OAK POINTE CHURCH JSP23-21

Approval of the request of Oak Pointe Church, JSP23-21: Preliminary Site Plan for a building addition with a children's play area totaling approximately 1,000 square feet, and a patio addition. The subject parcel is in Section 20 of the city, east of Napier Road, west of Wixom Road, and north of Ten Mile Road. The property is zoned RA, Residential Acreage and the initial multiple phase site plan for the property was approved in 2001.

Oak Pointe Church Additions
JSP23-21

Oak Pointe Church Novi Additions Site Plan Review - Response Letter

1 PRELIMINARY SITE PLAN
SPA-3 1" = 50'-0"

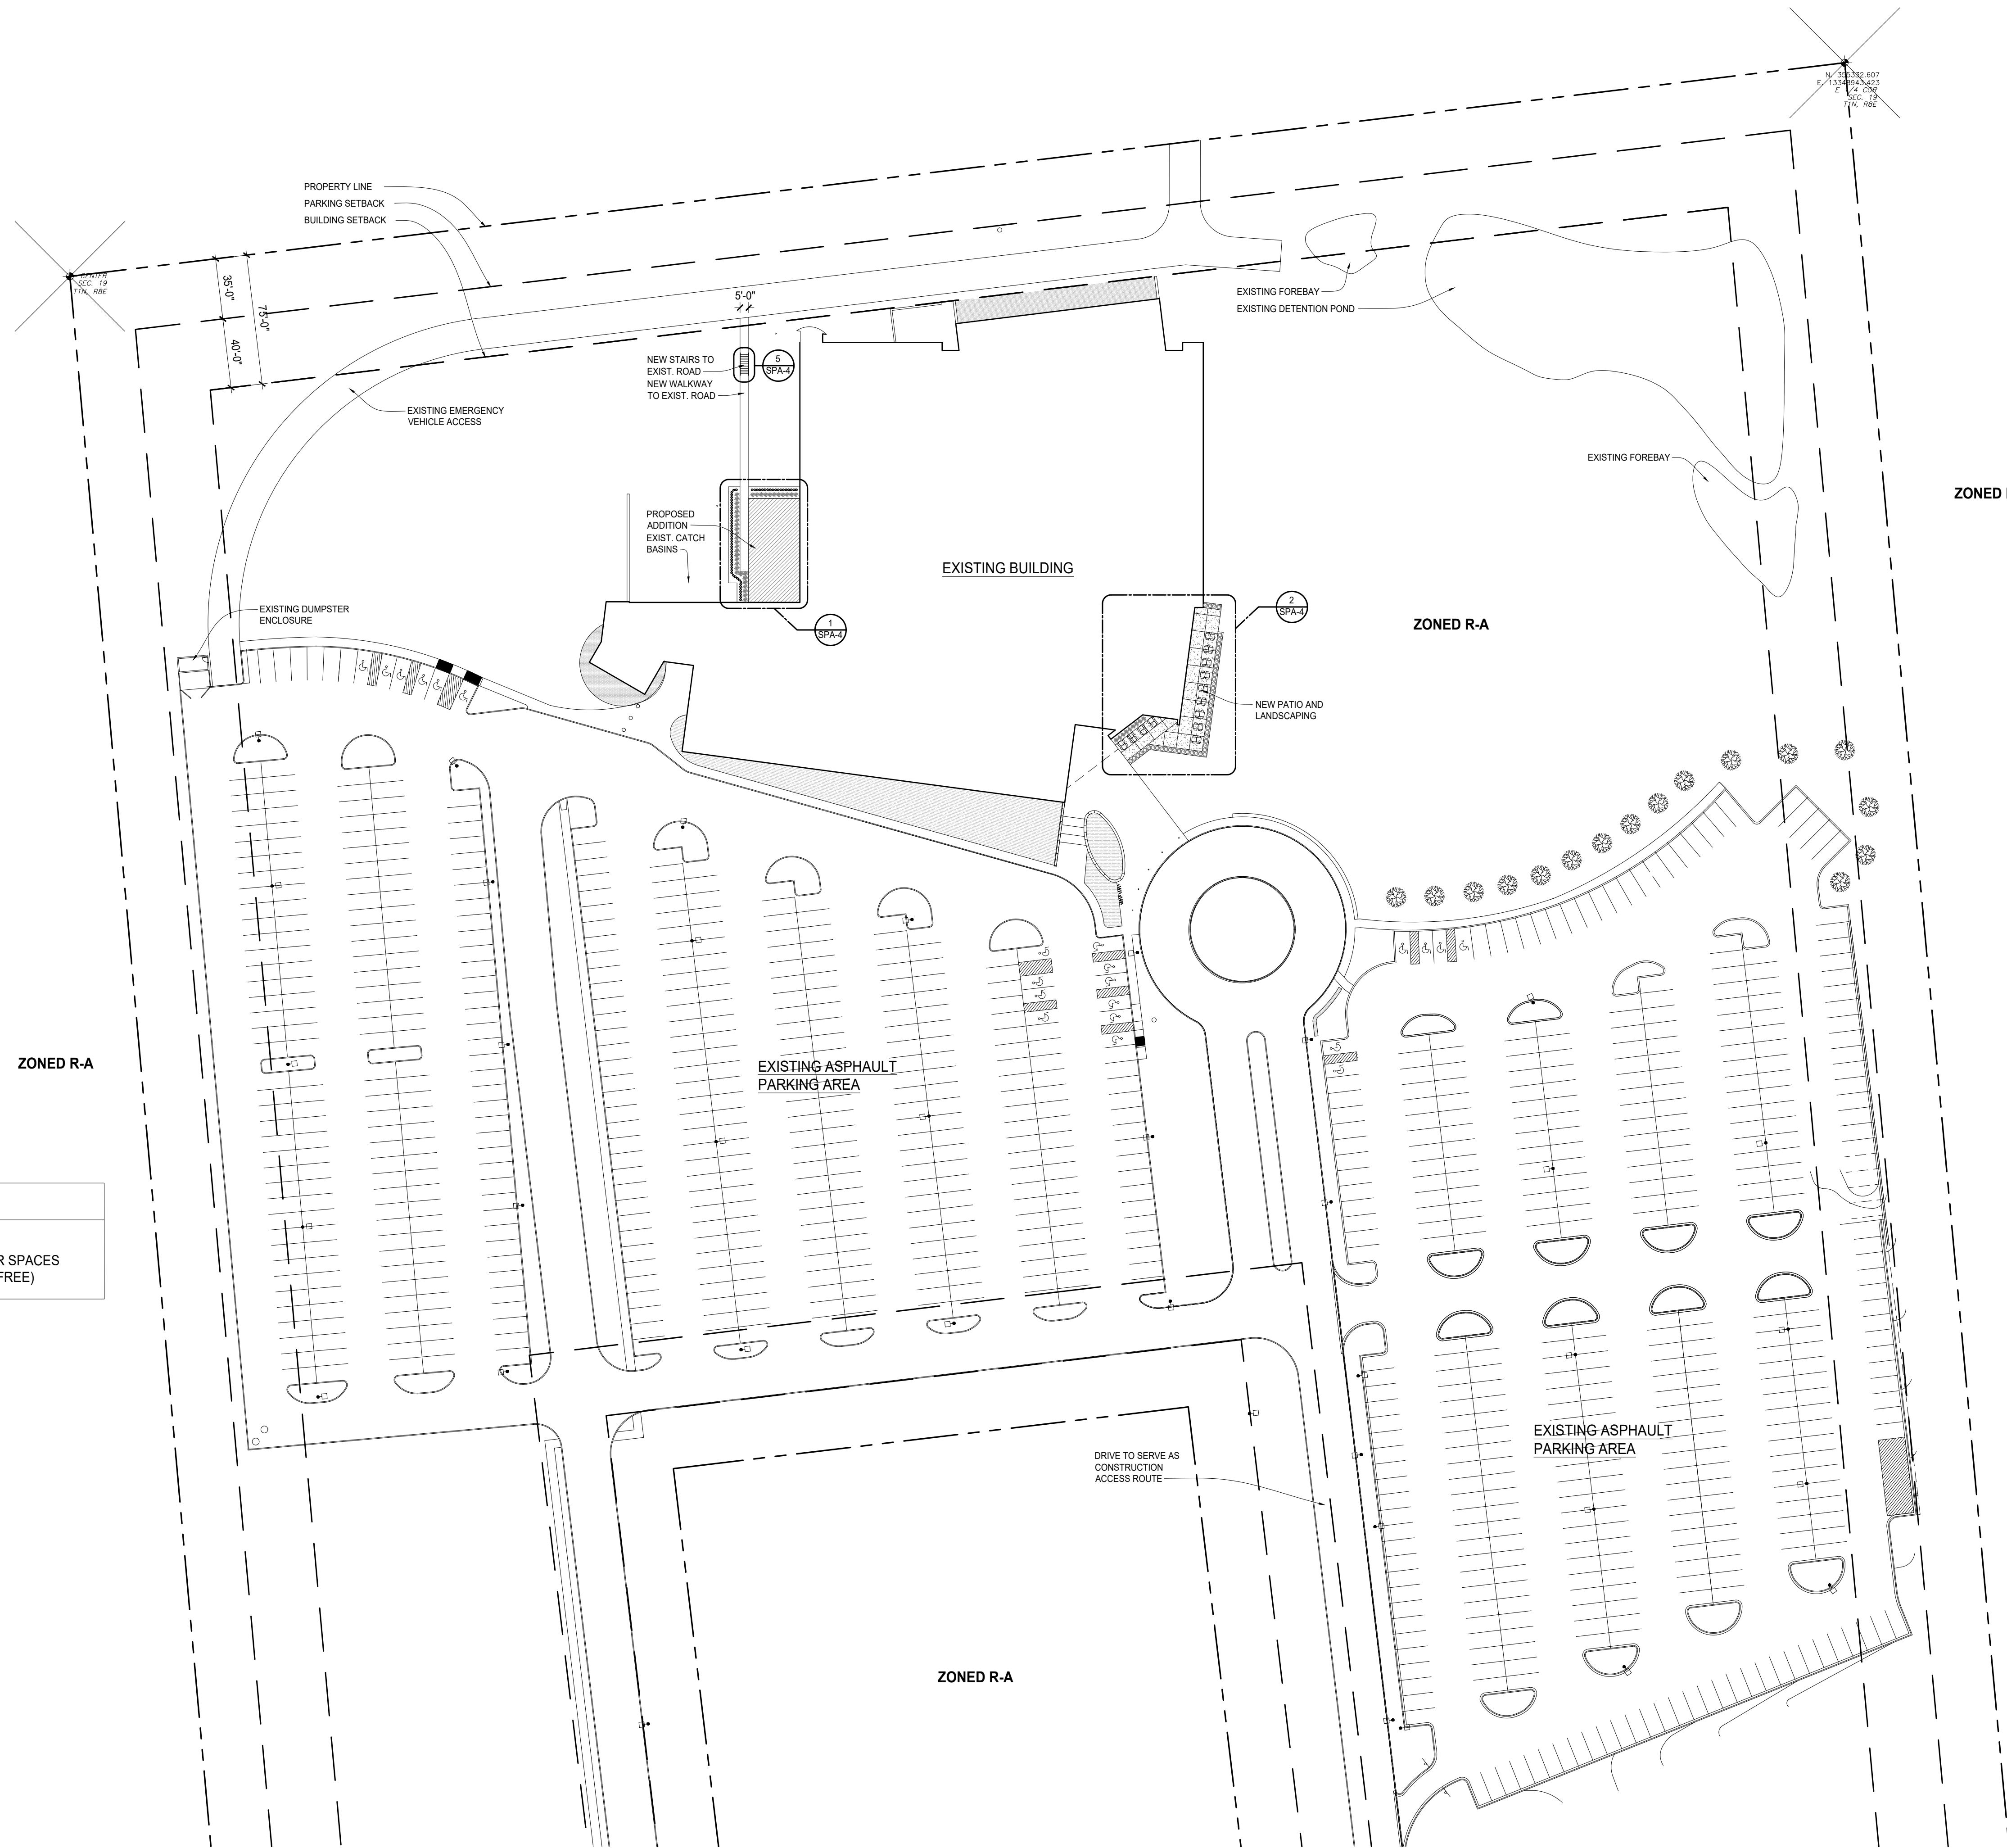
For plans showing more than twenty (20) occupants within the outdoor seating area, requirements for off-street parking for outdoor restaurants shall be computed according to the standards contained in Section 5.2, as indicated for restaurant use. **Please provide the parking calculations with the revised site plan submittal.**

The submitted set does not include a site plan according to the requirements of the city. Please provide a plan labeled Preliminary site Plan that is to the scale of no more than 1"=50". Please ensure that the sets contain all of the relevant details that are noted on the plans (some sheets were missing, such as sheet A-202, A-301, A-401, A-500, etc.)

- Scale of the provided site plan has been revised.

- Parking calculations have been added to the site plan. The existing parking is in compliance with the proposed cafe seating.

2 CAFE PATIO
SPA-4 1/8" = 1'-0"

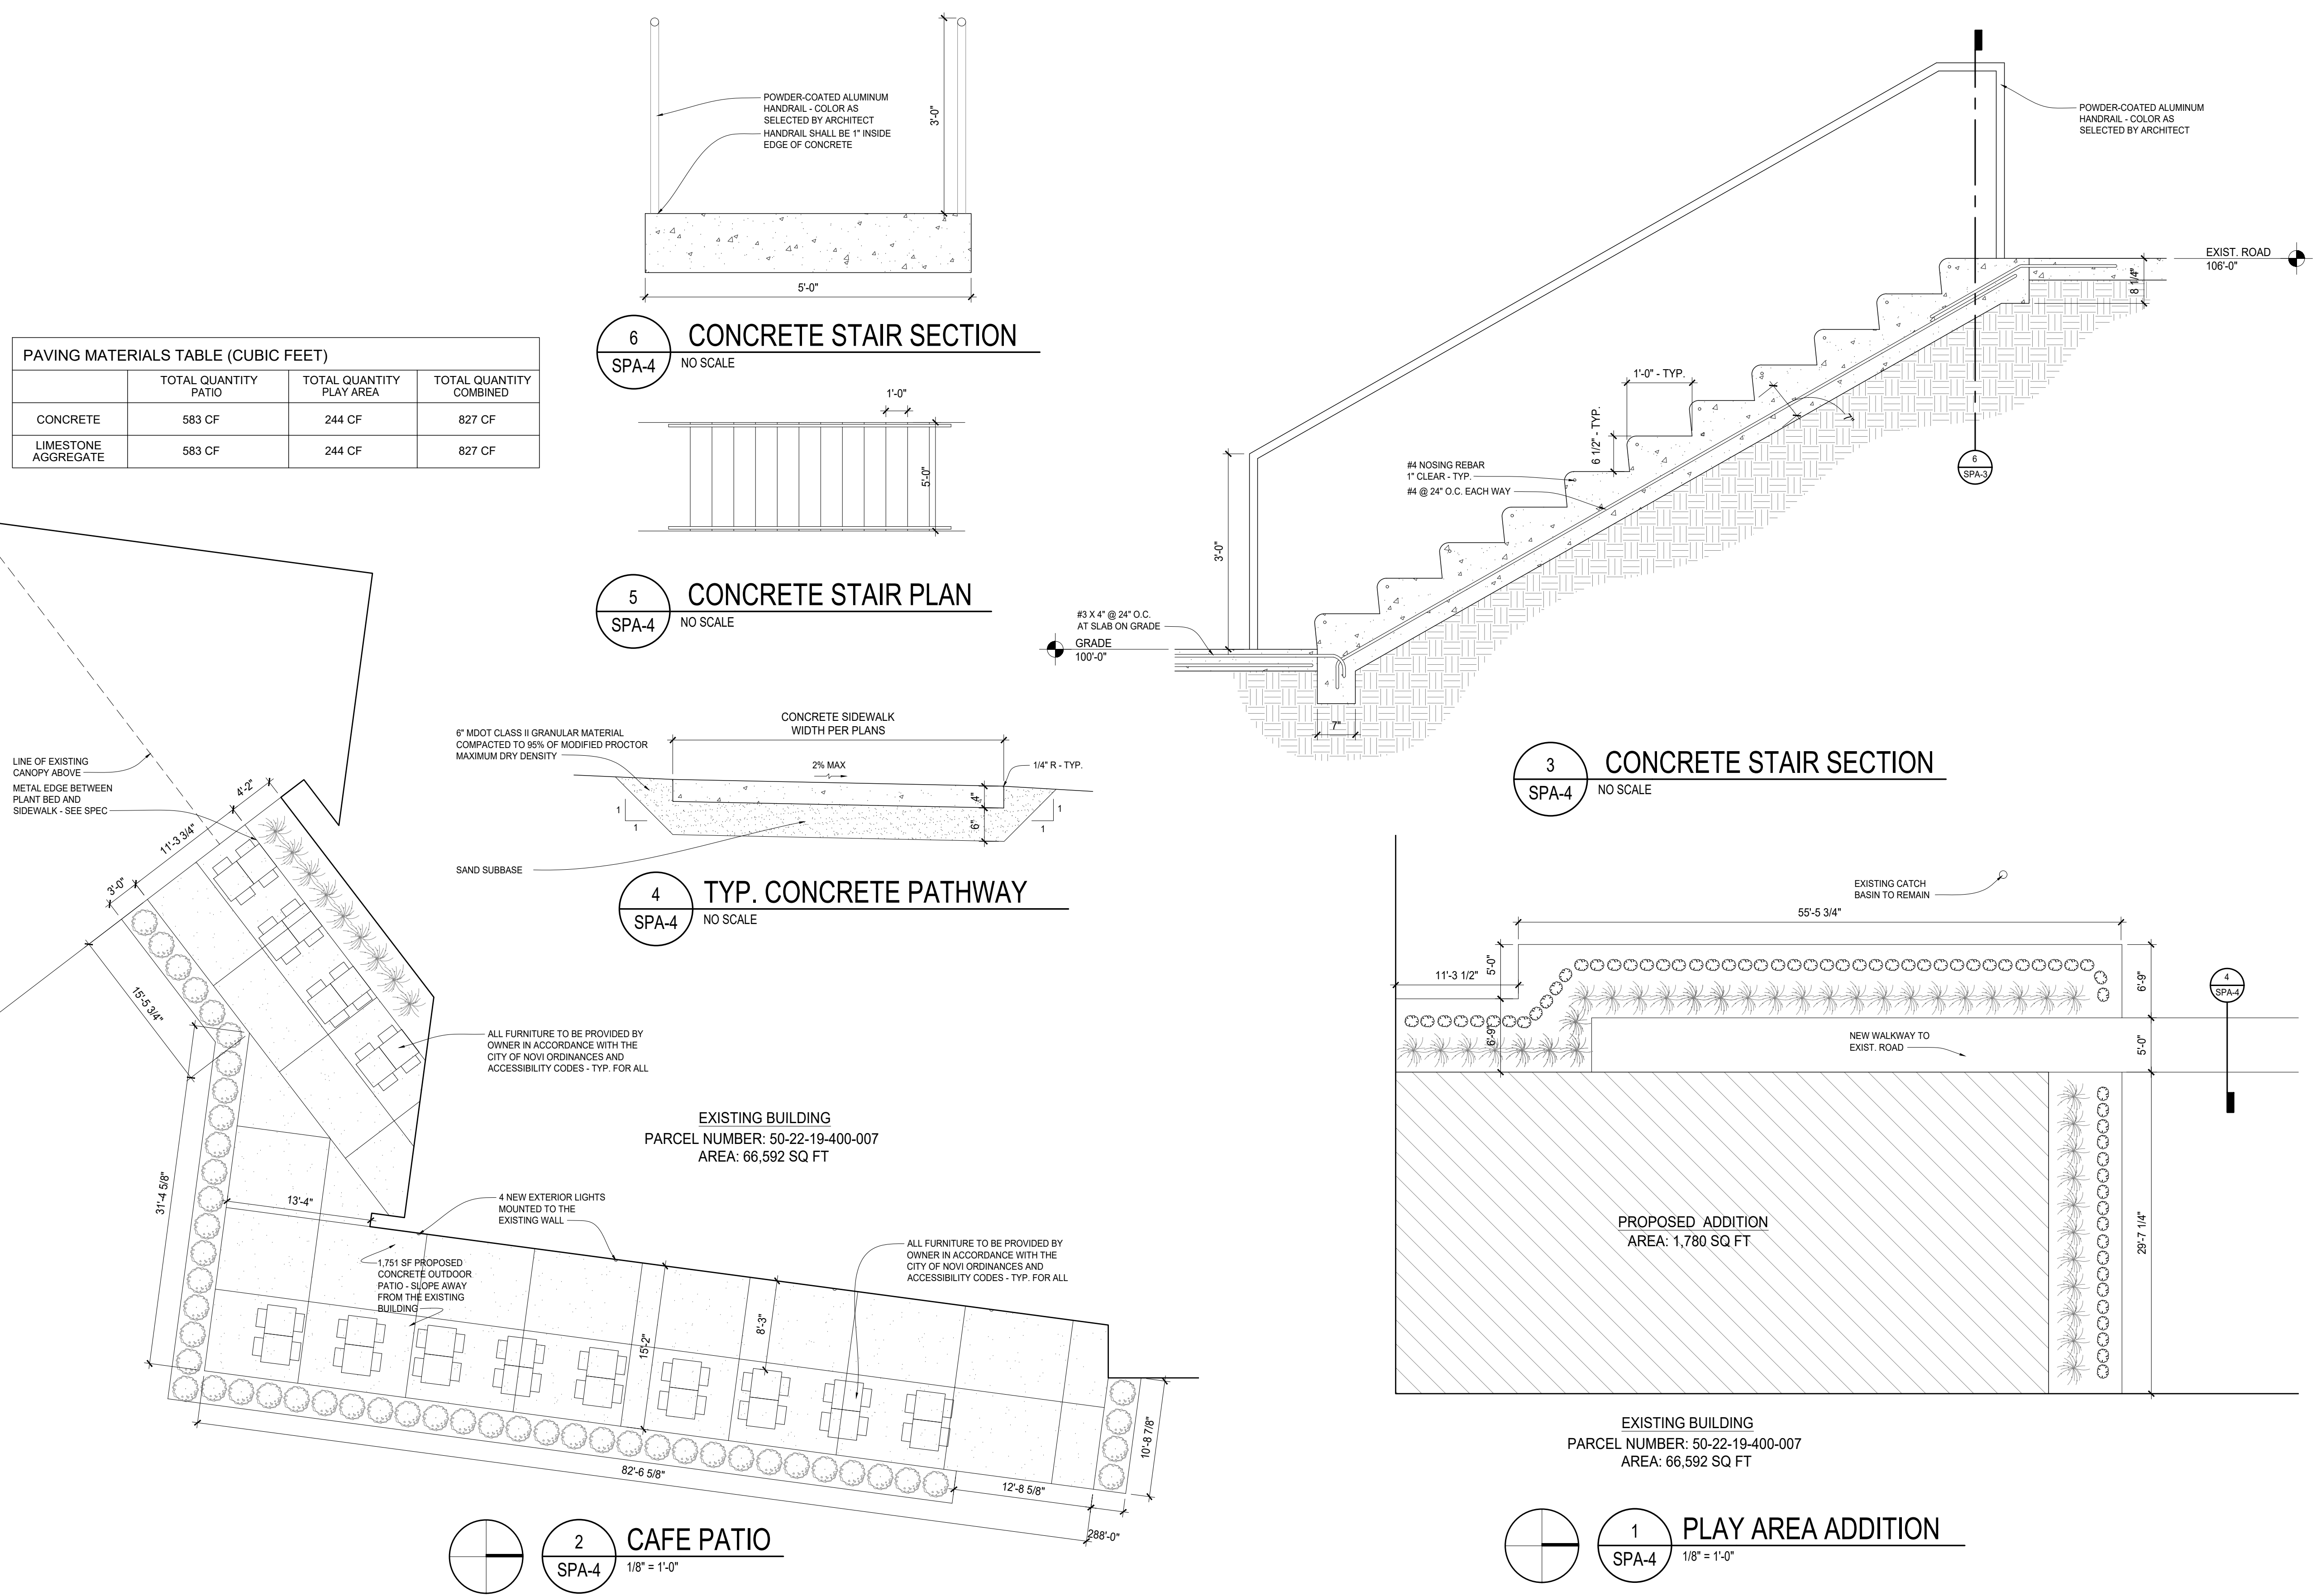
Please provide the dimensions of the clear pathways that are proposed.

- Dimensions have been added to the patio plan.
